**NON-COMPLIANCE REPORT # 32659-50**

PART NAME: **PROBE WELDMENT**  
 PF/SA NO.: **SA-382-907-87**  
 WORK ORDER NO.: **32659-50**  
 VENDOR **MFD**

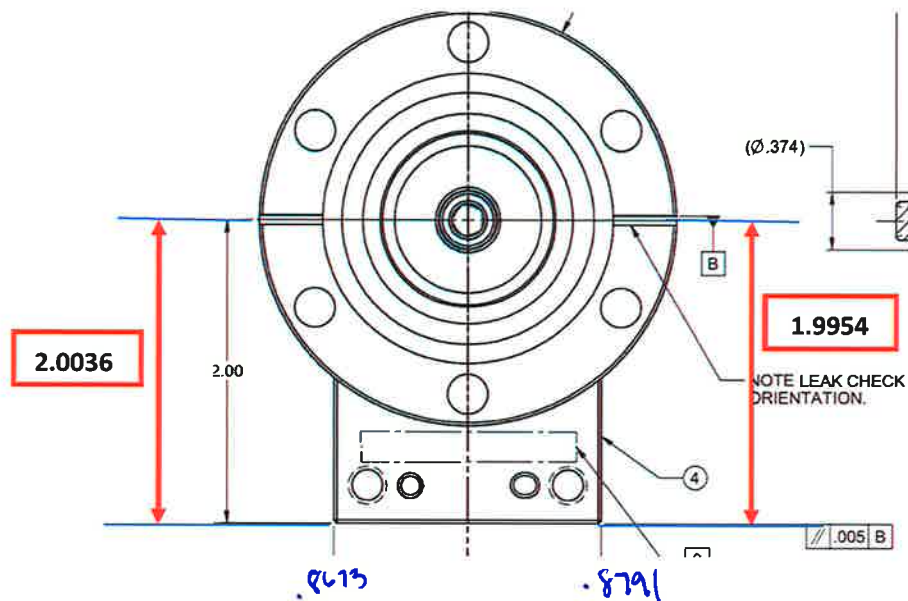
1.  $\boxed{\text{//.005 B}}$  is out of tolerance, measuring 0.00815.

*UAI*  
*2/29/16*  
*11:50am*
